**Santa Margarita River  
Flood Control Project  
MILCON Project P-010**

**Basilone Road Bridge  
Replacement  
MILCON Project P-030**

**FINAL  
ENVIRONMENTAL IMPACT STATEMENT**

### FINAL ENVIRONMENTAL IMPACT STATEMENT SANTA MARGARITA RIVER FLOOD CONTROL PROJECT (P-010), BASILONE ROAD BRIDGE REPLACEMENT PROJECT (P-030), AND CLEAN WATER ACT 404(b)(1) EVALUATION CAMP PENDLETON, CALIFORNIA

**Figure 2.3-1**

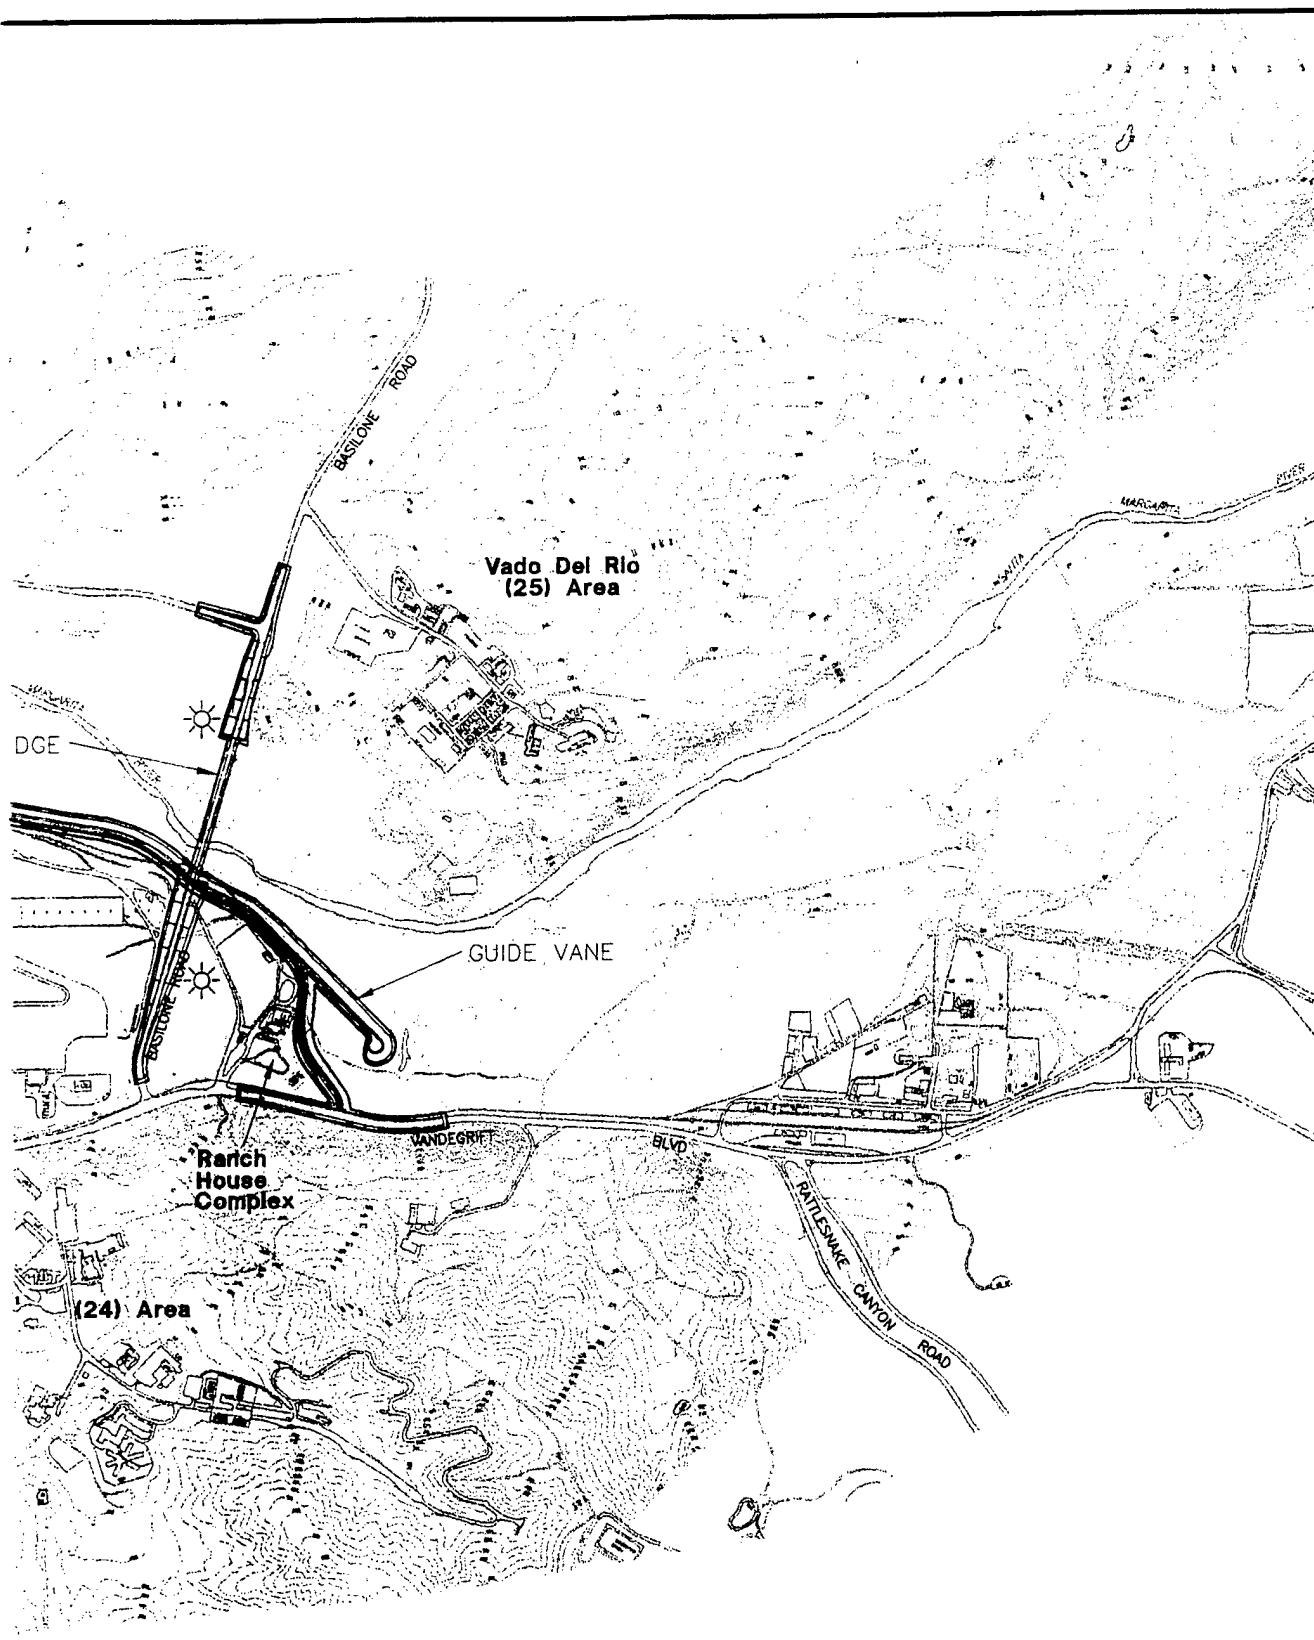
3.16	16	2-5	Fig 2.3-1	SPECIFIC COMMENTS  Section 2.0 Proposed Action and Alternatives, 2.3 Alternatives to Implement the Proposed Action, Figure 2.3-1 "Alternative 3A-Preferred Alternative", Pg. 2-5. Since the storm water management system is a component of Alternative 3A, the FEIS should indicate the location of the existing earthen ditch, proposed pump station, and discharge point on this figure.	Comment noted. Figure 2.3-3 on page 2-9 provides an illustration of the existing earthen ditch with reference to the floodwall. Figure 2.3-4 is a detailed drawing of a plan view of the proposed pump station that includes identification of the outlet portion of that structure.

Section 2.0 Proposed Action and Alternatives, 2.3 Alternatives to Implement the Proposed Action, Figure 2.3-1 "Alternative 3A-Preferred Alternative", Pg. 2-5 Since the storm water management system is a component of Alternative 3A, the FEIS should indicate the location of the existing earthen ditch, proposed pump station, and discharge point on this figure.

Figure 3.3 - 2

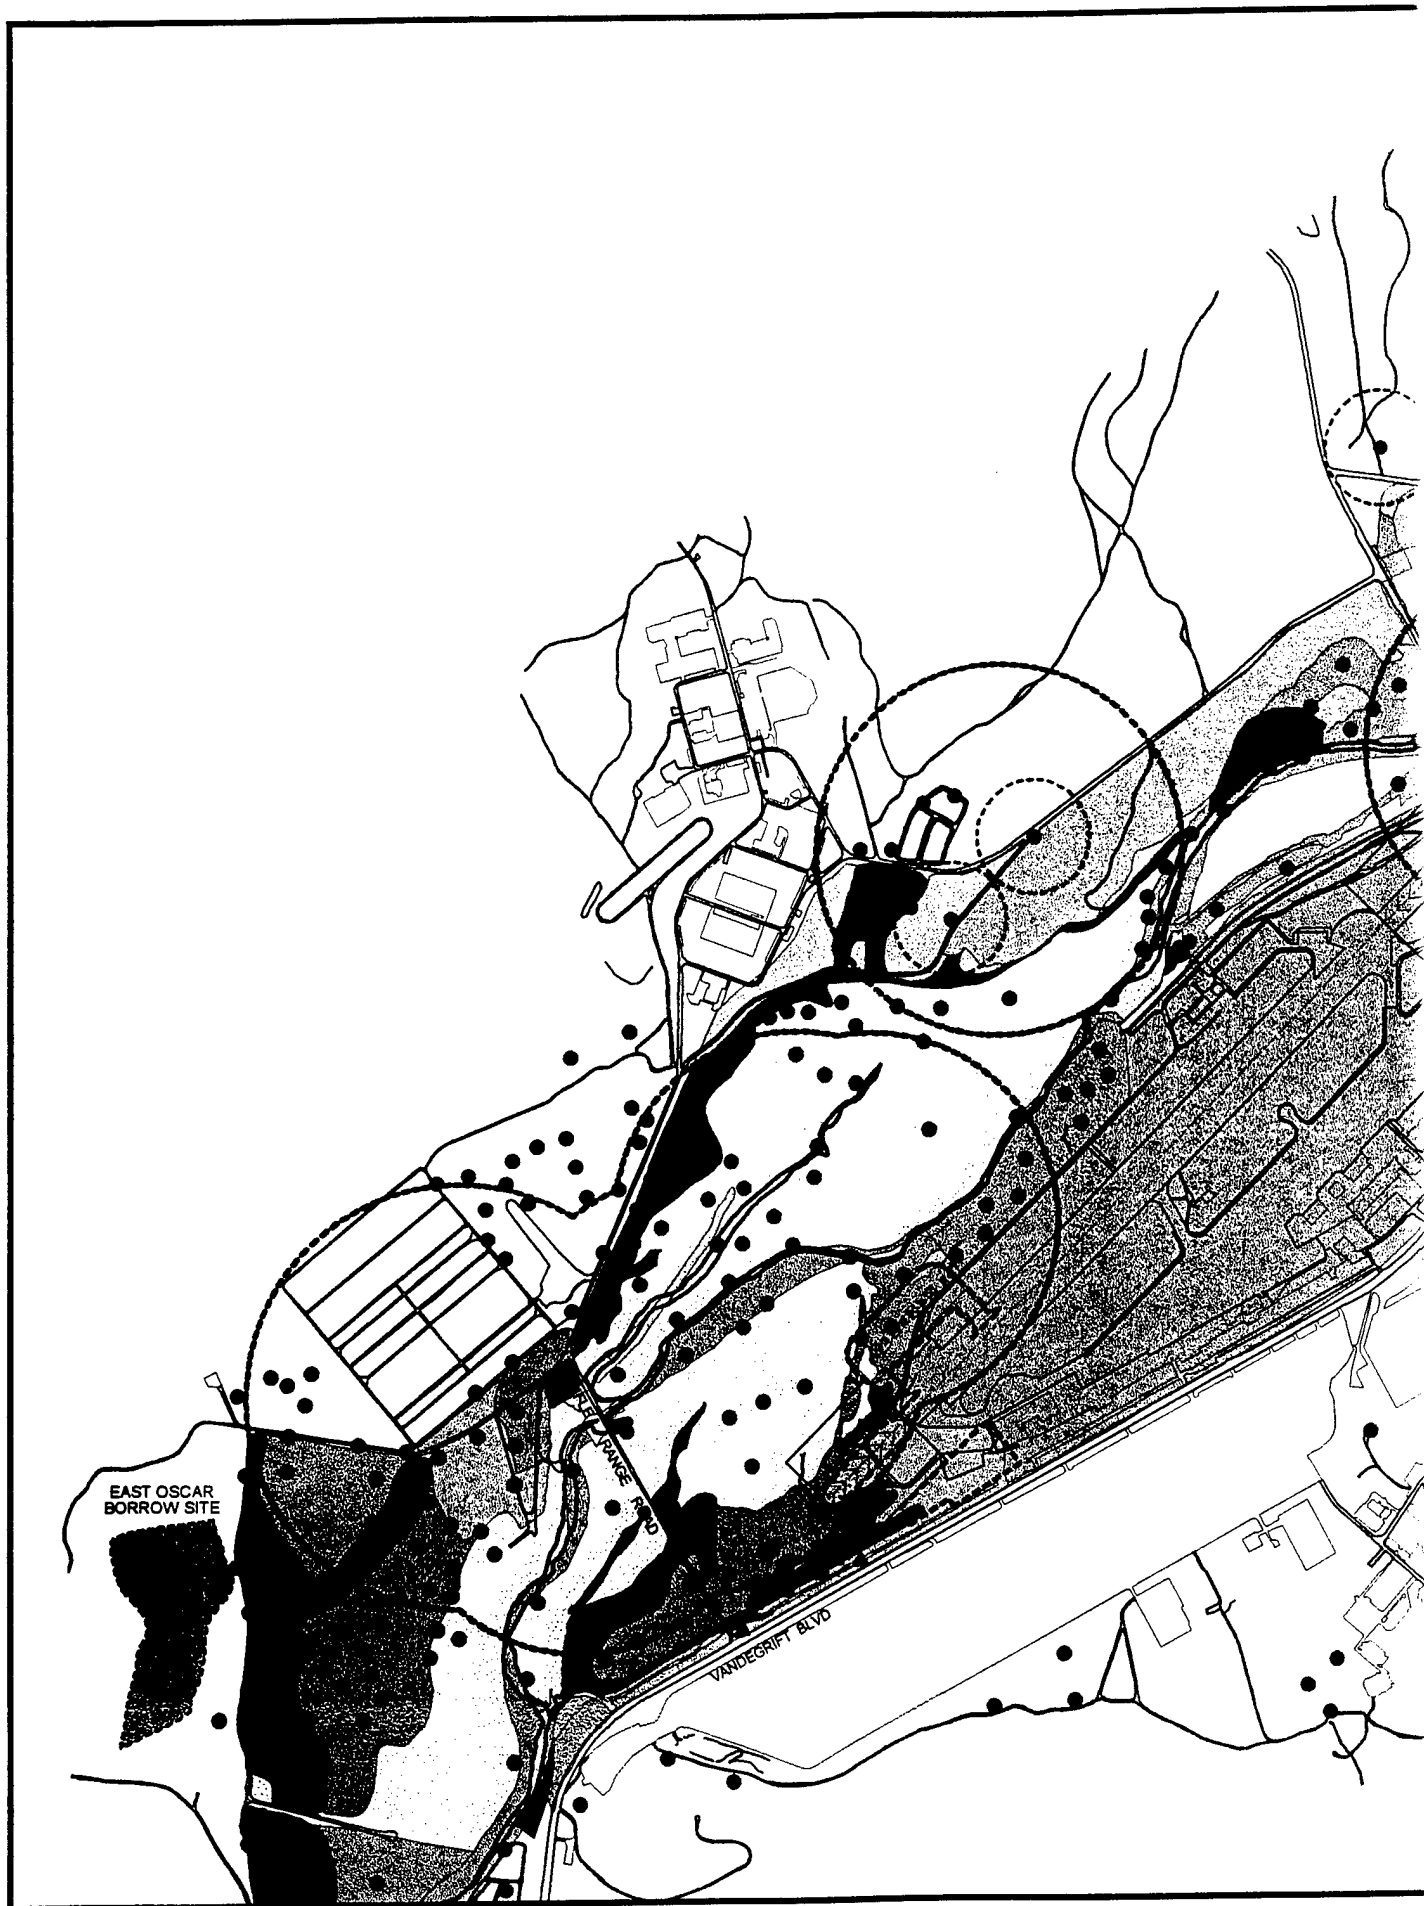
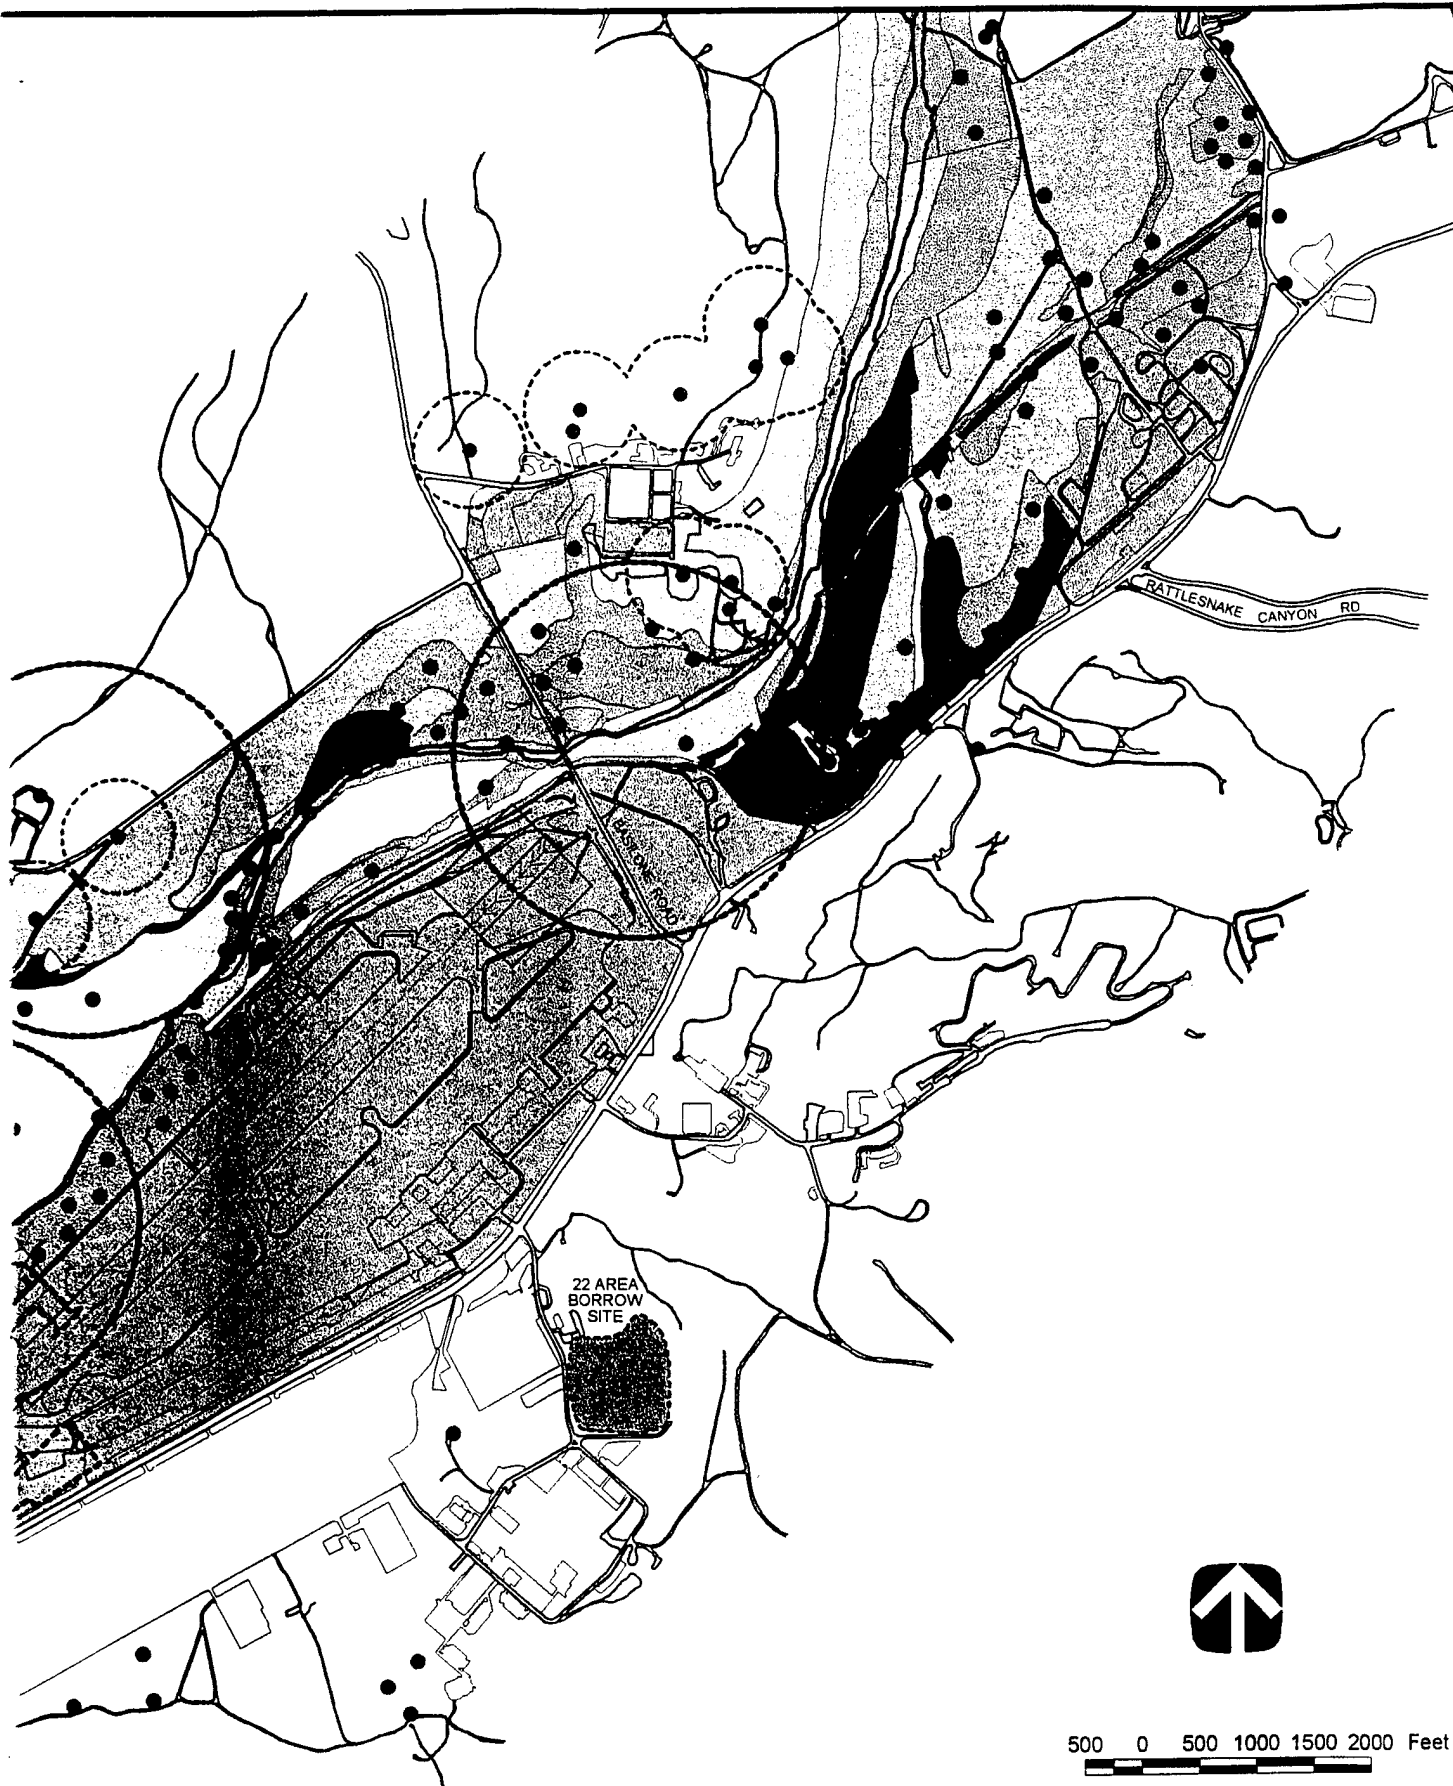
3.08	8	3.3-9	Fig 3.3-2	According to the DEIS, the preferred alternative levee/floodwall alignment footprint would occur primarily within areas designated as grass-forb and Arundo. However, based on the Service's review of 1994 aerial photographs, Status Report 2, and the location of federally listed species as shown in Figure 3.3-2 "Sensitive Species", there appears to be a discrepancy regarding the habitat communities found within the project area. For instance, three Flycatcher locations are identified within an area mapped as grass-forb (Figure 3.3-2). However, Status Report 2 and a review of 1994 aerial photographs indicate this area riparian woodland.	Comment noted. Figure 3.3-2 "Sensitive Species" has been revised to provide greater detail of habitat communities.

3.20	20	3.3-9	Fig 3.3-2	Section 3.0, Affected Environment, 3.3 Biological Resources, 3.3.3 Figure 3.3-2 "Sensitive Species", Pg. 3.3-9. Survey information regarding the occurrence of the California gnatcatcher within the area influenced by the proposed action should be included on this figure in the FEIS.	Comment noted.. A 1994 survey did not identify any California Gnatcatchers within the areas of influence of the proposed project. Only one Gnatcatcher was been found and it was outside the project area. As a result, no adverse impacts to this species would occur. The location of the individuals discovered during the survey is not shown on Figure 3.3-2 due to its scale.

3.21	21	3.3-12	3.3.3	Section 3.0, Affected Environment, 3.3 Biological Resources, 3.3.3 Figure 3.3-2 Sensitive Species, Southwestern Willow Flycatcher, Pg. 3.3-12. The DEIS states that four pairs of Flycatchers were present within the general project area and an additional eight Flycatchers of undetermined breeding status were identified. However, Figure 3.3-2 "Sensitive Species" does not indicate the location of the additional eight Flycatchers. This information should be provided in the FEIS.	Comment noted. Figure 3.3-2 has been revised to include the 8 Flycatchers of undetermined status and the text revised based on a data review.

ID #	Comment No.	Page	Section	Comment	Response
14.10	1	3.3-8	3.3.3	<b>Biological Resources</b>  1. Page 3.3-8: The Draft EIS reports that the coastal California gnatcatcher, southwestern flycatcher, least Bell's vireo, and arroyo southwestern toad are federally-listed species known to occur in the proposed project area. Figure 3.3-2, <i>Sensitive Species</i> , however, provides information only about the three latter species. The Final EIS should include coastal California gnatcatcher information on this diagram.	Comment noted. A 1994 survey did not identify any California Gnatcatchers within the areas of influence of the proposed project. Only one Gnatcatcher was been found and it was outside the project area. As a result, no adverse impacts to this species would occur. The location of the individuals discovered during the survey is not shown on Figure 3.3-2 due to its scale.

According to the DEIS, the preferred alternative levee/floodwall alignment footprint would occur primarily within areas designated as grass-forb and Arundo. However, based on the Service's review of 1994 aerial photographs, Status Report 2, and the location of federally listed species as shown in Figure 3.3-2 "Sensitive Species", there appears to be a discrepancy regarding the habitat communities found within the project area. For instance, three Flycatcher locations are identified within an area mapped as grass-forb (Figure 3.3-2). However, Status Report 2 and a review of 1994 aerial photographs indicate this area as riparian woodland.

Figure 3.10-2

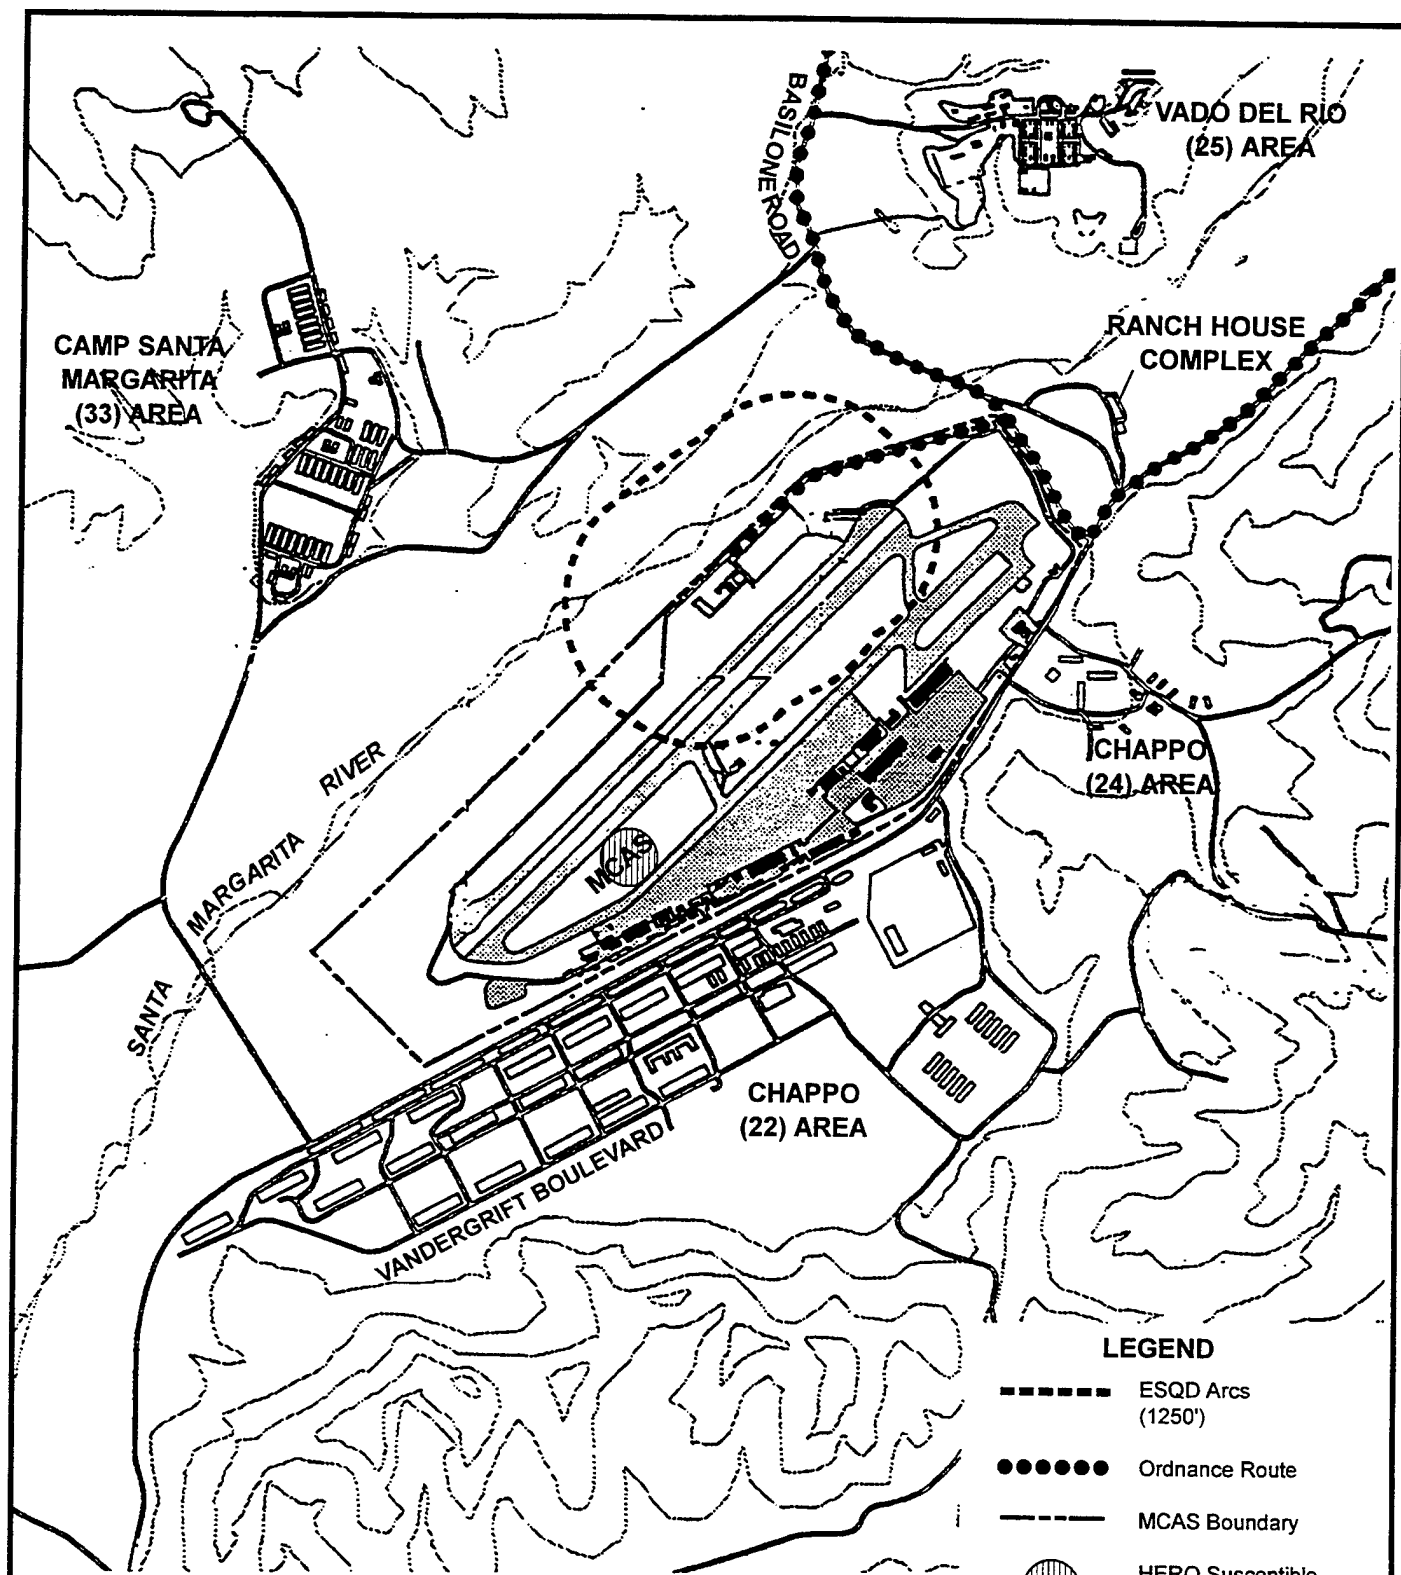
6.30	17	4-10.7	4.10.4	17. Section 4.10.4. Worker safety as it pertains to explosive safety has not been addressed. Section 3.10.3, Figure 3.10-2 shows that a significant portion of the Project levee falls within the ESQD. Since it is stated that a minimum separation from explosives handling and storage applies to public traffic routes and inhabited buildings, it would appear that there would be a risk of exposing the construction workers to potential hazards from an explosion. HERO restrictions, if any, on the use of radio transmitters by construction workers should be defined.	Comments noted. A discussion of worker safety in the ESQD has been added to Section 4.10.
